# Technical News

## Tightening torque for air supply (Mercedes Benz) 4185 N P21 / 4390 N P21 / 4758 N P21 / 4757 N P01 / etc.

Figure (a)

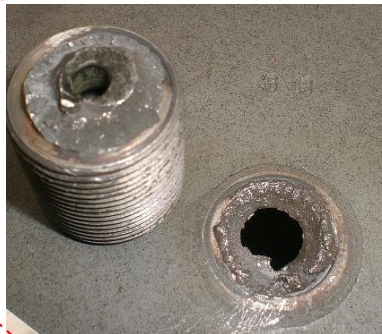
Unlike many other air springs, these Mercedes types are fastened at the top only by the combi-air supply fitting shown in the figure. This connection has been designed to match the loads associated with the fitting.

In the past year, increased numbers of air spring systems have been sent back with the fitting having torn off. The fault occurs at the point marked (a).

The failure pattern is similar on nearly all the air spring systems which have been inspected. A detailed view is given in Figure (b).

The conical top plate on the returned air spring systems meets the specifications of the vehicle manufacturer. Load tests regularly performed on the threaded fitting as part of our quality assurance measures significantly exceed the given maximum value.

- (1) Tightening torque too high
- (2) Oil and/or grease applied to thread

The failure pattern described is not caused by a production or material failure!

Maximum permissible tightening torque for the air supply fitting according to manufacturer specification: **100 Nm\***. \*("Dry state" = Use of lubricants must be avoided, as these reduce friction, thus causing the threaded fitting to be overloaded when the recommended tightening torque is used.)

It is strictly recommended to use suitable torque wrenches in order to ensure controlled assembly.
